May 8, 1992
LD-92-065

Docket No. 52-002

Subject: System 80+™ Supplements to RAI Responses

ATTACHMENT 1

Figure 1
Examples of Alarm Coding

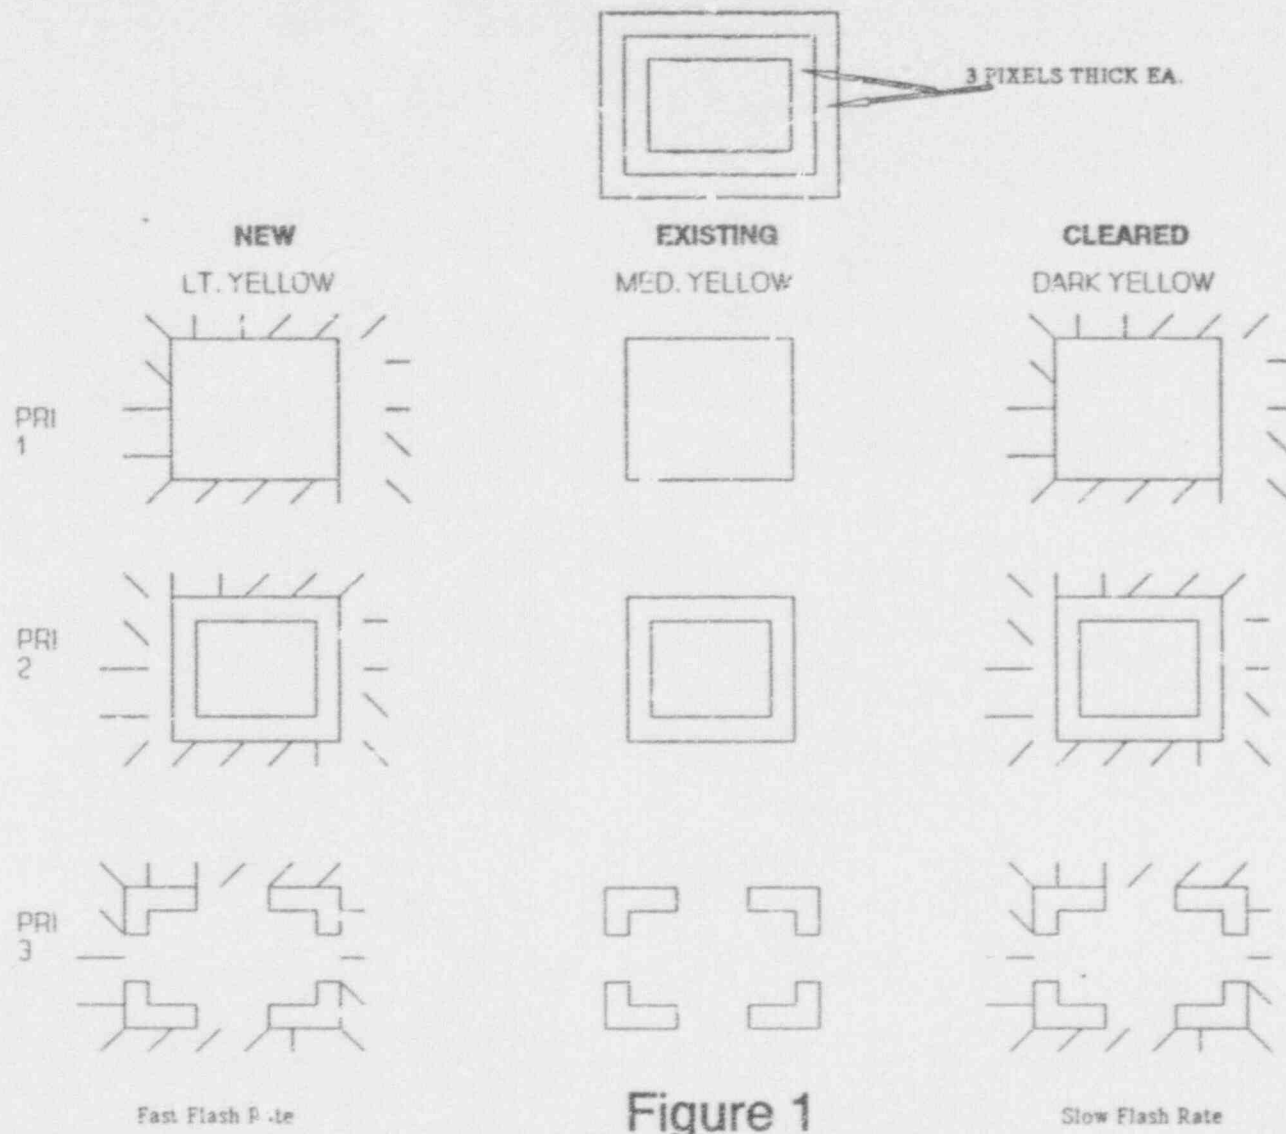
Alarm Priority: Alarms are shape and salience-coded for priority with increasing salience corresponding to higher priority. Salience levels were chosen by empirical evaluation of prototypes. See Figure 1 and Table 1 for details.

Alarm Status: Changes in status of alarms are indicated by flashing and hue, good attention-getting features (per EPRI NP 3659, et. al.). Fast and slow flash rates are used as described in Table 1. Exact flash rates are still to be determined but will fall within the ranges of NUREG-0700. Duty cycles of 50-50 and 25-75 are used as appropriate based on NASA-3000. See Table 1 and Figure 1 for details. Three hues of yellow were selected to allow coding of multiple-status alarm tiles. The 3 hues were acceptable per NASA-3000 and prevented masking, a common problem with multiple input or combined alarms on existing systems.

Panel Expansion Schedule

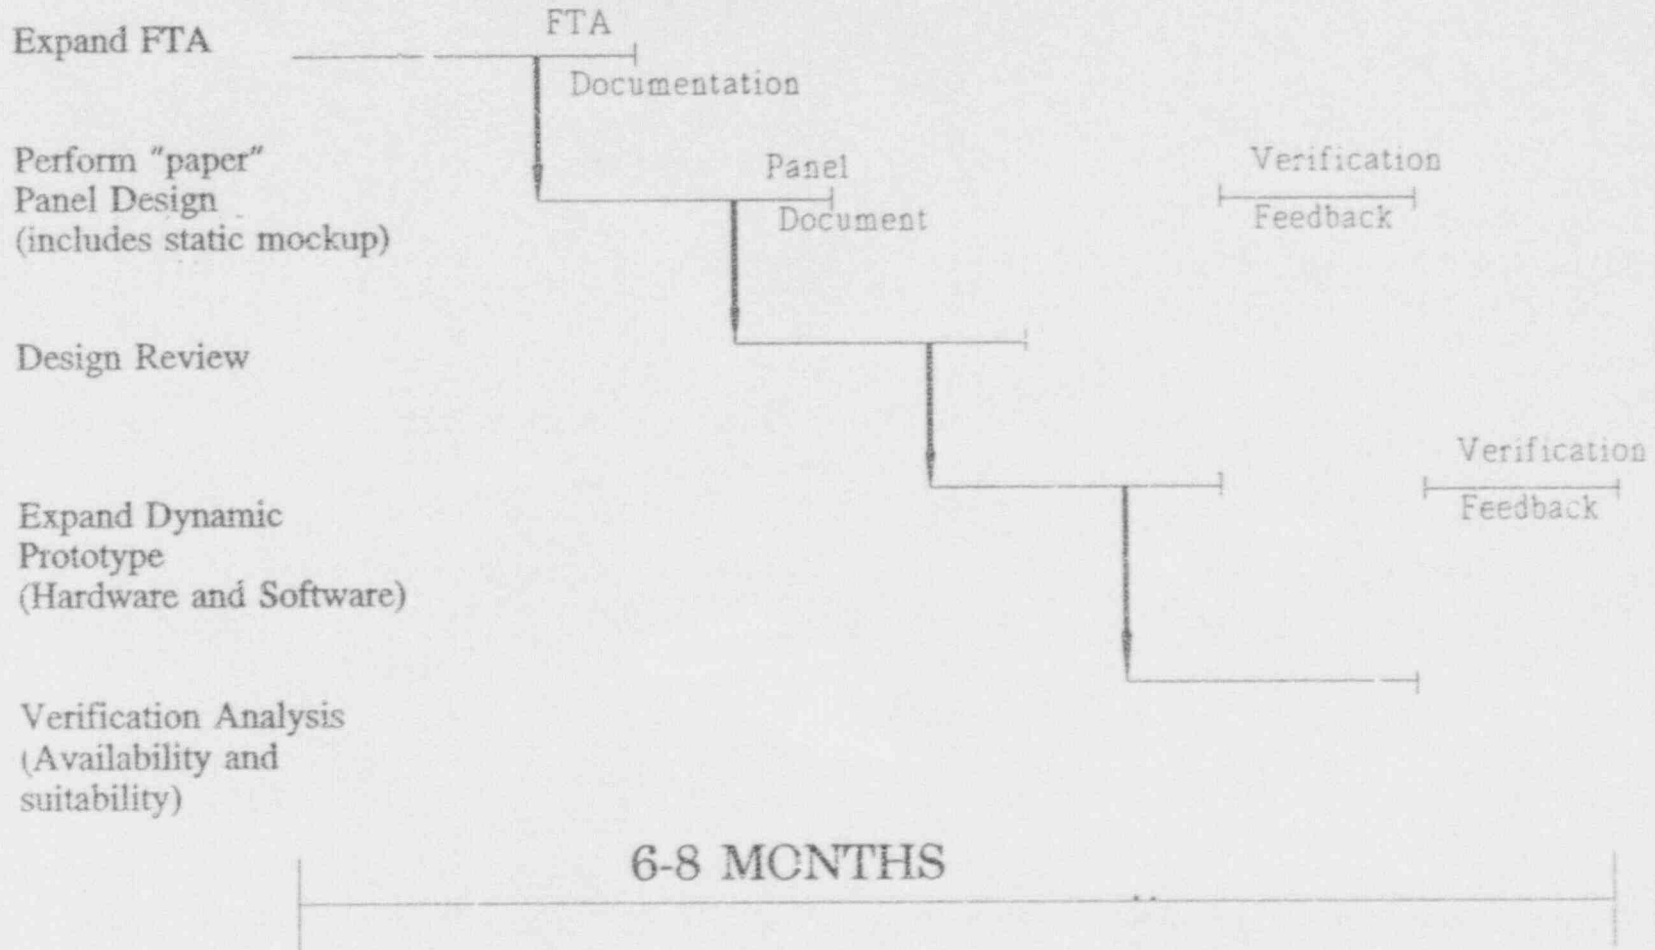
Response: This statement refers to both demonstrating hardware and software attributes and the suitability of the interface from a human factors perspective. The Nuplex 80+ design process has already and will continue to do hardware attribute evaluations using prototypes, and hardware configuration studies on prototypes to assure adequate throughput. Software studies have prototyped software implementations using ladder logic programming in programmable logic controllers and software required for data processing features such as success path monitoring, alarm processing and signal validation. As described in other RAI responses, these evaluations have not been formal human factors studies.

The man-machine interface devices have also been evaluated from a human performance perspective as part of the verification analysis documented in the Verification Analysis Report NPX-IC-TE-790-01 and discussed in the response to Question 620.30. The suitability analysis evaluated both the man-machine interface devices as stand-alone devices and in the context of the ensemble of Nuplex 80+ interface devices.
